MODIFYING A WORD CLOCK INPUT FOR LOW LEVEL SOURCE

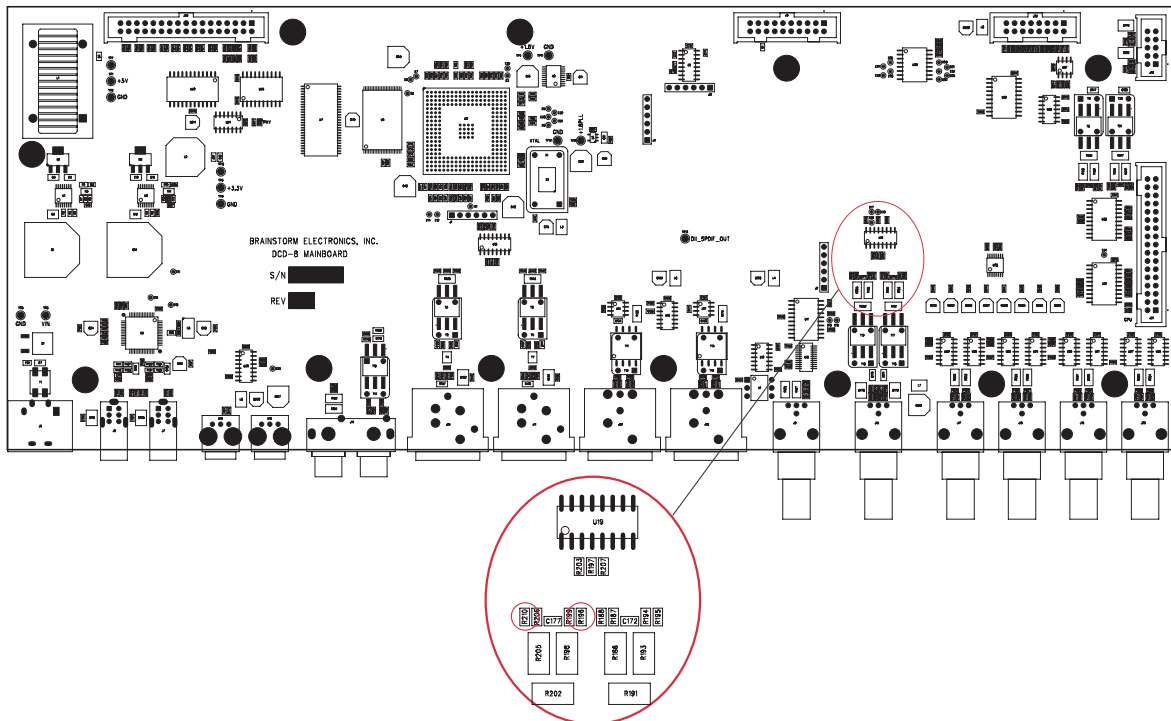
For those situations, 2 resistor values can be changed so that the required level be only 0.59Vp-p.

Typically, we would recommend modifying WC Input 2 only, leaving the other 2 inputs unchanged.

- locate R196 and R210. Normal value for both resistors is 4.7K Ω .
- Replace them by 10.5K Ω resistors.

Inputs 1 & 3 can be modified the same way. The resistors to change for those inputs are:

- INPUT 1: R188 & R195
- INPUT 3: R214 & R221
